**SECOND RESPONSE TO REQUEST FOR ADDITIONAL INFORMATION  
PERMIT TO OPERATE COMPOSTING FACILITY  
PERMIT TO CONSTRUCT LEACHATE TREATMENT FACILITY  
PERMIT TO OPERATE RESOURCE RECOVERY FACILITY  
WASTE TIRE GENERAL PERMIT  
AND  
PERMIT TO MAINTAIN CLOSED CLASS I SANITARY LANDFILL  
PREPARED FOR**

Mr. Kim B. Ford, P.E.  
Solid Waste Section  
Division of Waste Management  
Florida Department of Environmental Regulation  
4520 Oak Fair Boulevard  
Tampa, Florida 33610-7347

**RE: SUMTER COUNTY SOLID WASTE FACILITIES**

**PERMIT NO.:**      **S060-211179 - SOLID WASTE COMPOSTING**  
**WT60-211205 - WASTE TIRE STORAGE**  
**S060-211182 - M.R.F.**  
**SF60-211255 - LONG-TERM CARE**  
**SC60-211181 - LEACHATE TREATMENT**

Form No. 25-18-5/83

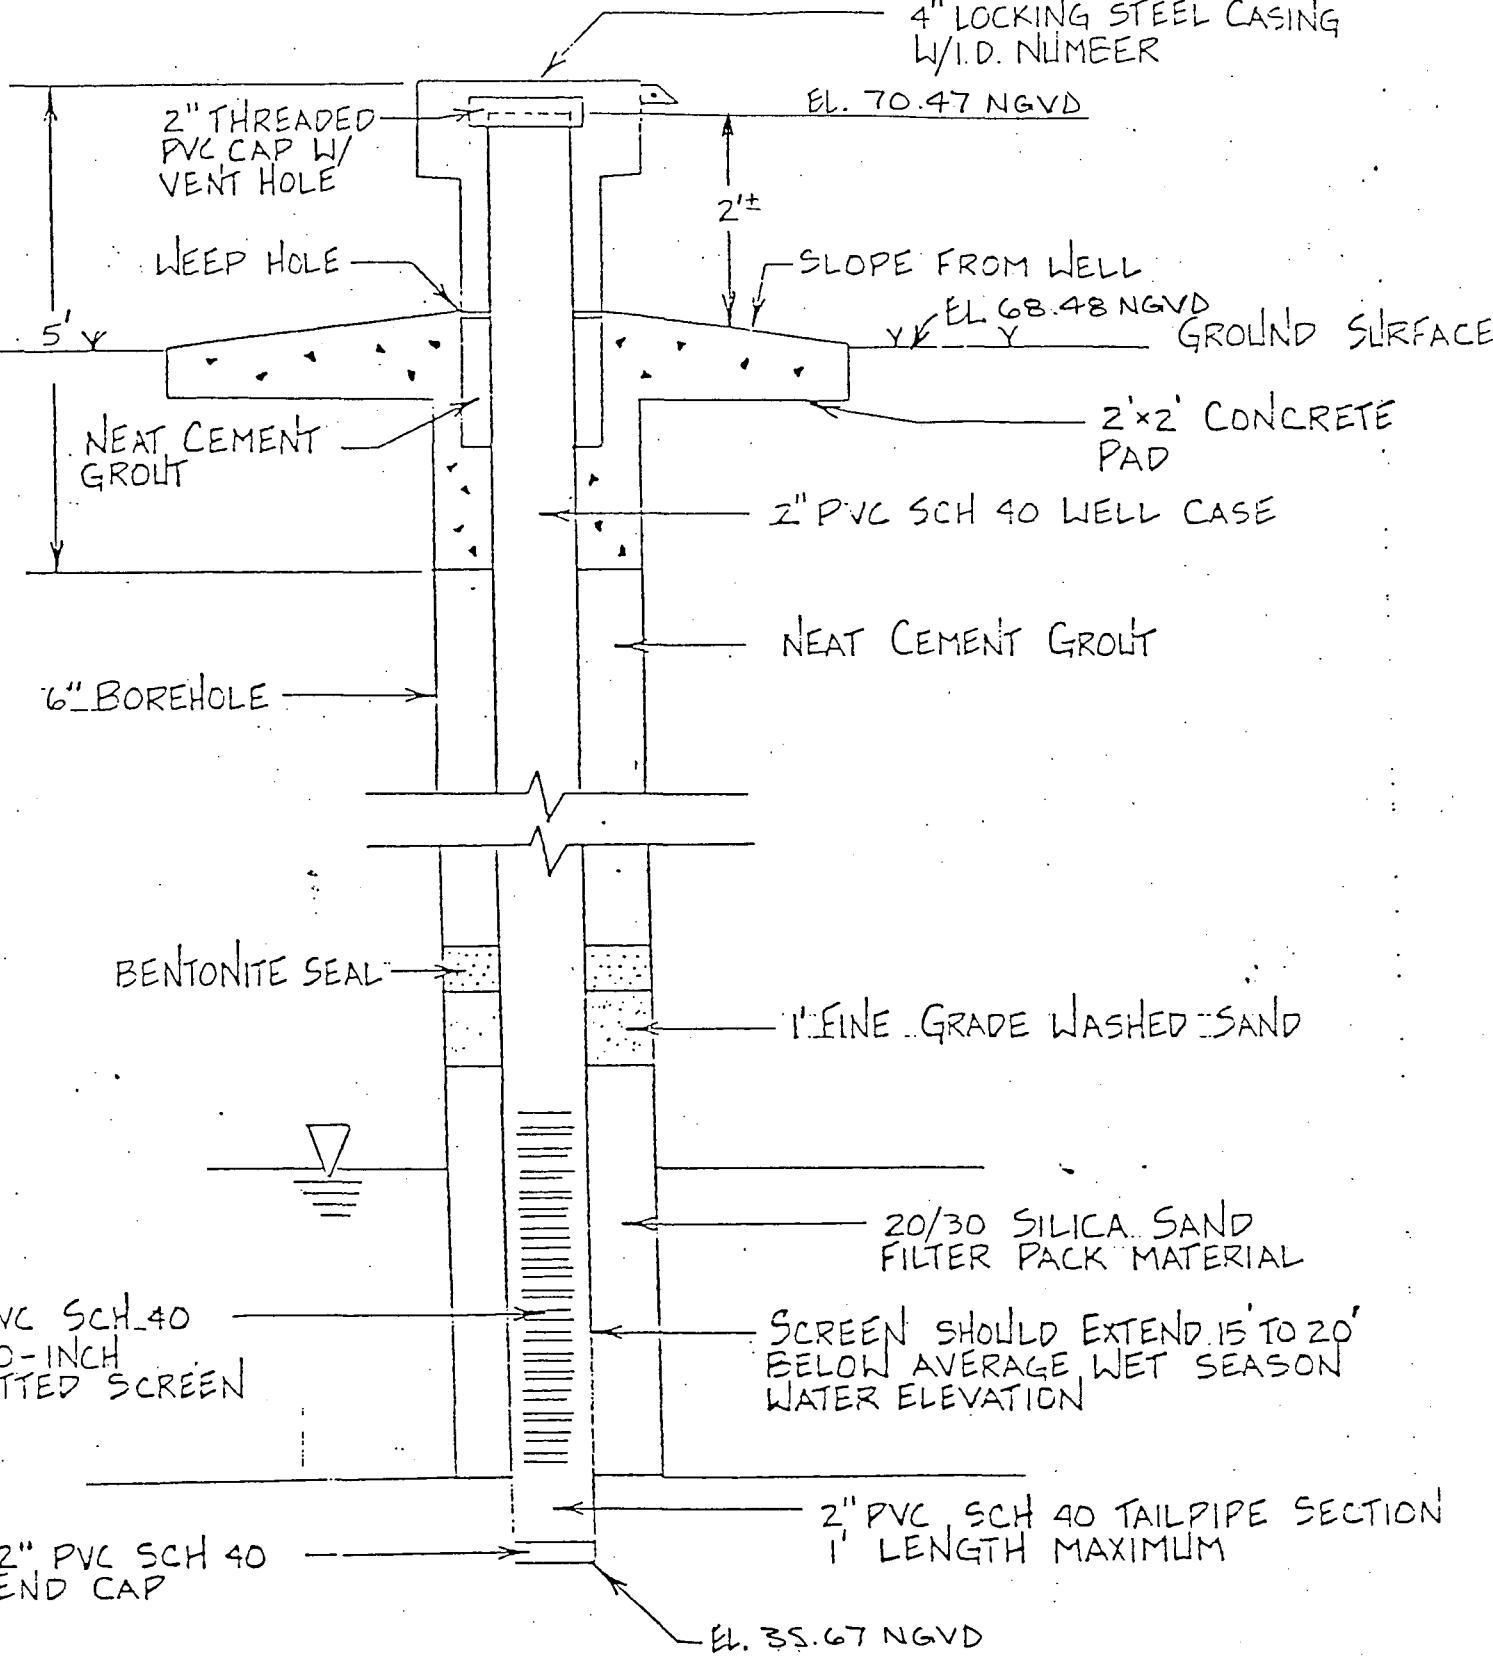
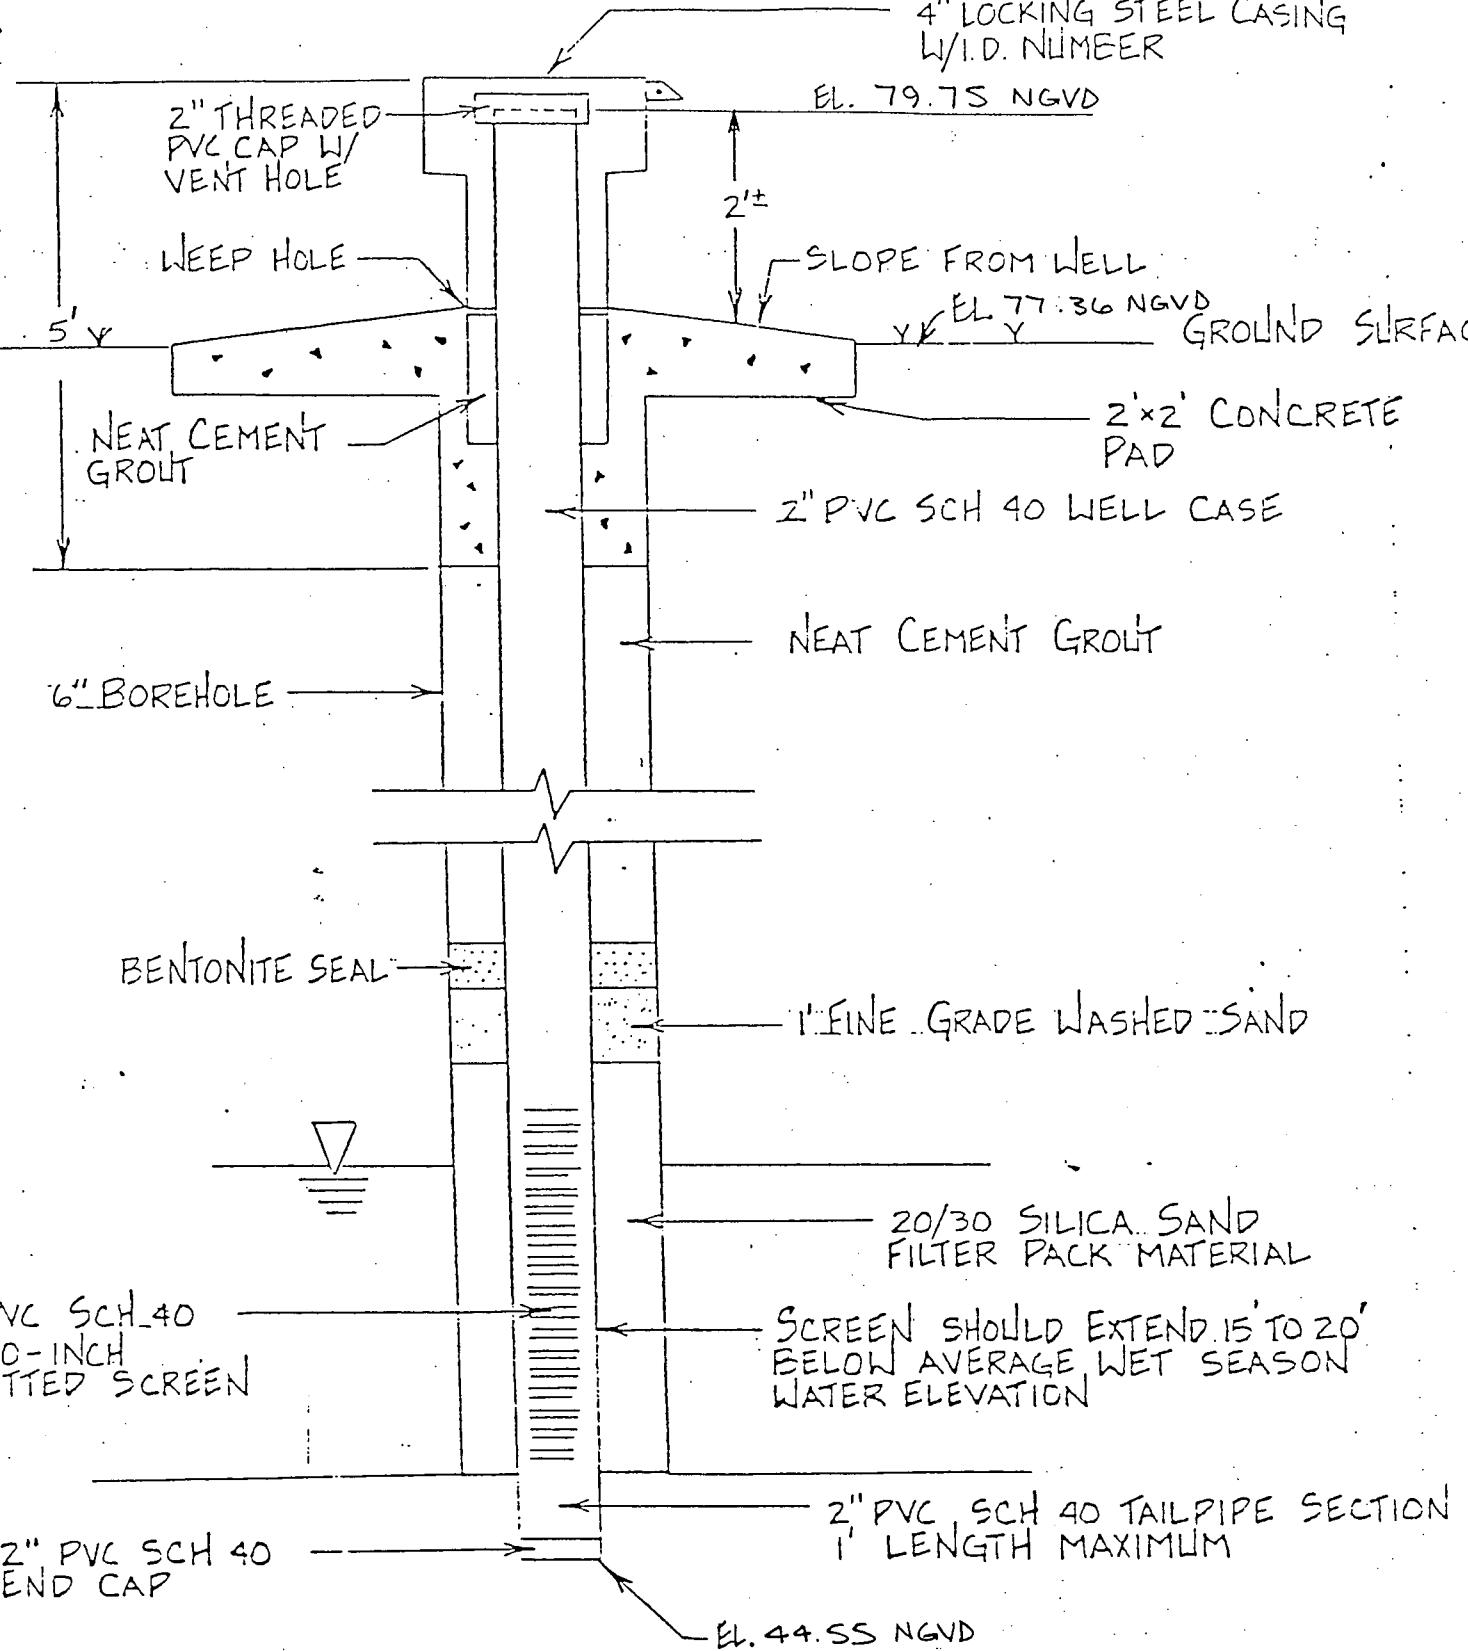
1. A monitor well construction detail was provided which indicates that the wells were constructed

with 2 foot screens and no bentonite seal between the screen and the cement seal. According to the Appendix E of the Environmental Compliance Branch Standard Operating Procedure and Quality Assurance Manual for the U.S. Environmental Protection Agency which deals with well construction, a well screen less than 5 feet shall not be employed except for temporary monitor wells. It is also stated that a seal is to be placed on top of the filter pack which consists of a high solids, pure bentonite material. The specific construction details for all monitor wells should be provided.

1. The well construction detail presented in our response dated May 29, 1992 was inadvertently taken from the original submission of the Groundwater Monitoring Plan, dated June 14, 1984, previously submitted to FDER and later revised at the request of FDER. The length of the screened interval was shown as being two (2) feet. This is inconsistent with the well completion reports prepared for the Southwest Florida Water Management District (SWFWMD) and the special well completion reports prepared for this project. The screened interval reported installed was five (5) feet. We suggest that the well completion reports be reviewed instead of the previously submitted well construction detail. The well completion reports and well construction details for each monitoring well are enclosed in Appendix B for your review and use.

A bentonite seal was installed above the filter pack material.
